1-25-85	Revised Quantities for Item No. 602.0600 Per C.O. No. 1.
12-31-84	Revised Quantities for Item Nos 206,5000, 206,8000, 602.0600, & 611.0100 Per Addendum No. 1.
DATE	REVISION
STATE OF HAWAII DEPARTMENT OF TRANSPORTATION LAND TRANSPORTATION FACILITIES DIVISION INDEX TO DRAWINGS & ESTIMATED QUANTITIES HANAMAULU VIADUCT HANAMAULU-AHUKINI CUTOFF ROAD Ahukini Road to Kauai Hardwoods PROJECT NO. F-051-1(4)	
SCALE: NONE DATE: SEPT., 1984 SHEET NO. 5-1 OF 541 SHEETS

HANAMAULU VIADUCT
HANAMAULU-AHUKINI CUTOFF ROAD
Ahukini Road to Kauai Hardwoods
PROJECT NO. F-051-1(4)

FRACTURED ROPE
ARCHITECTURAL SURFACE
TREATMENT DETAIL

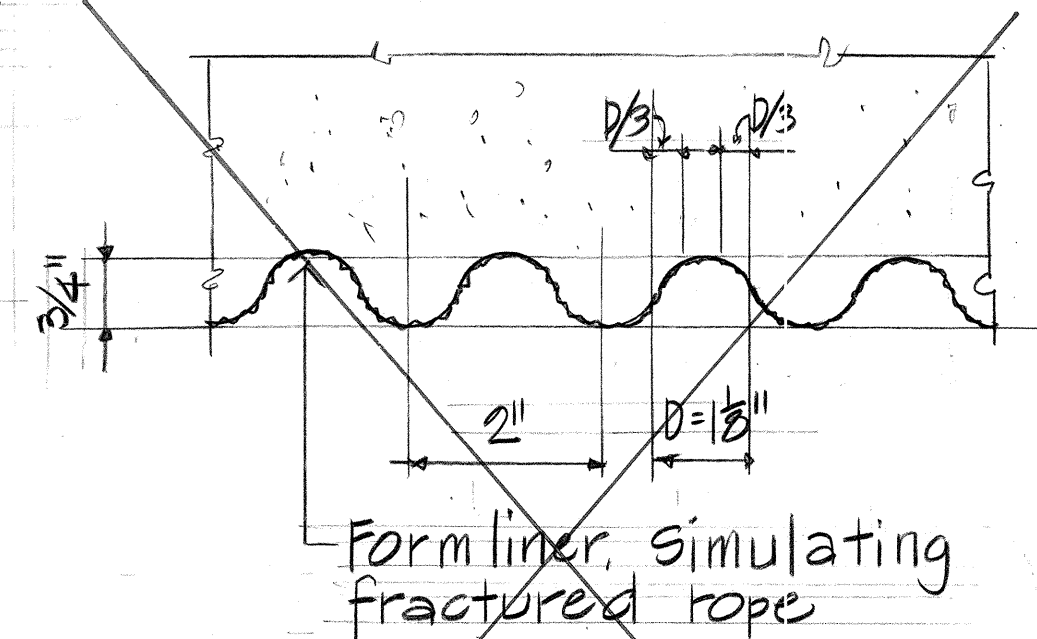
Deleted by Contract
Change Order No. 2.
